CP / CP PMIC
AB_ISTOR

VX_Setup(2016-01-20)_HHP

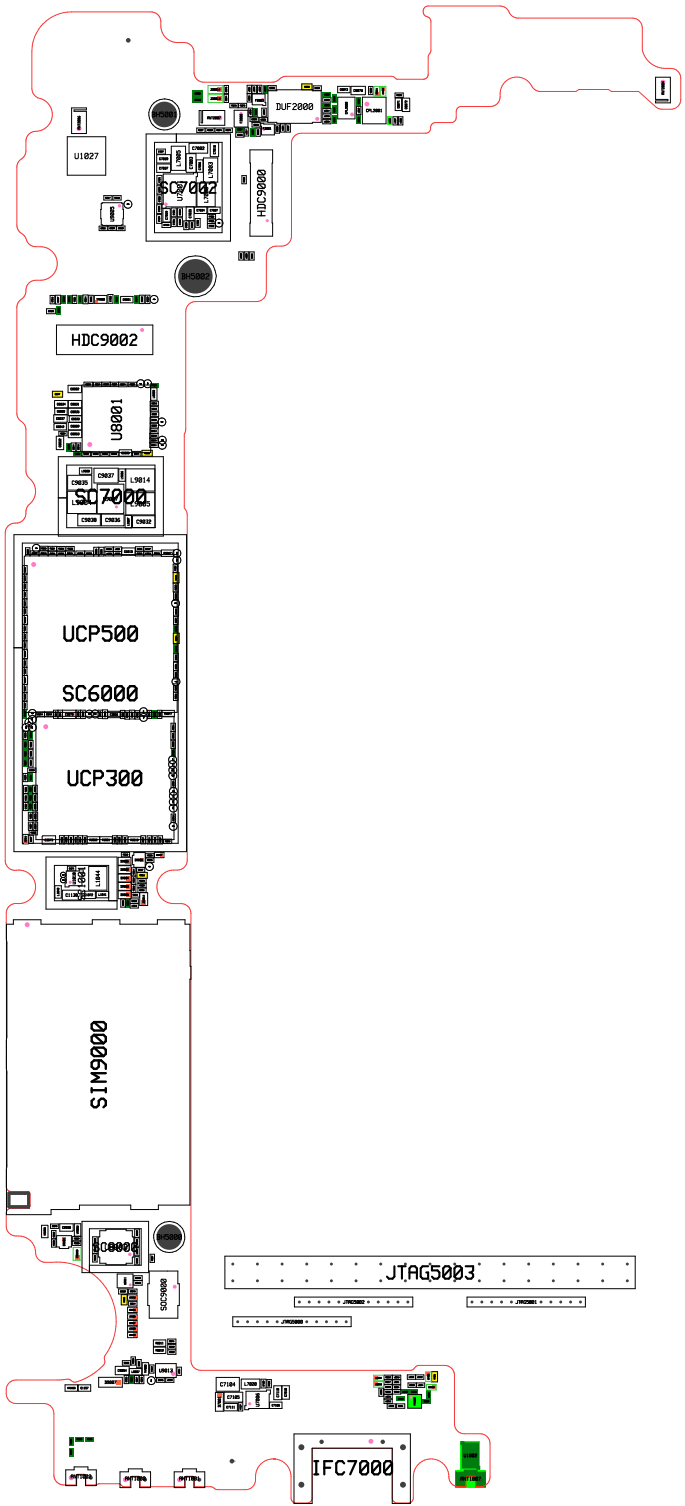
AON1605(TR7001) : IT'S Wrong Polar
ity possibility. Check the Pin1

VX_Setup(2016-01-20)_HHP

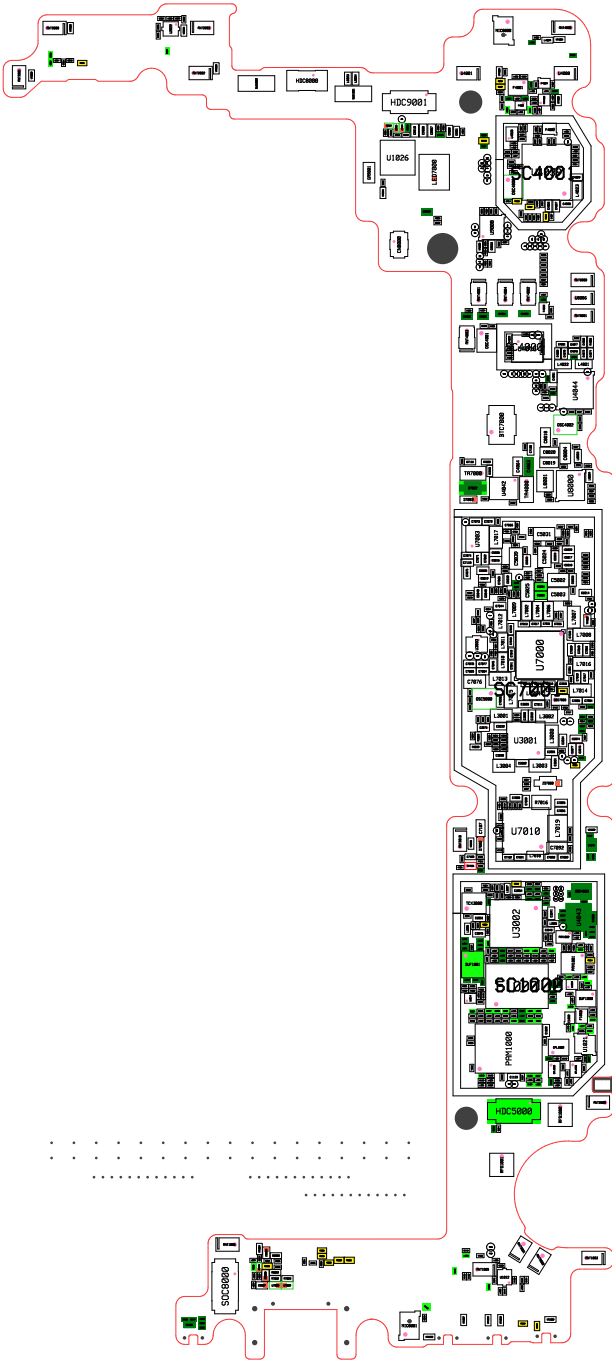
AON1605(TR7001) : IT'S Wrong Polar
ity possibility. Check the Pin1
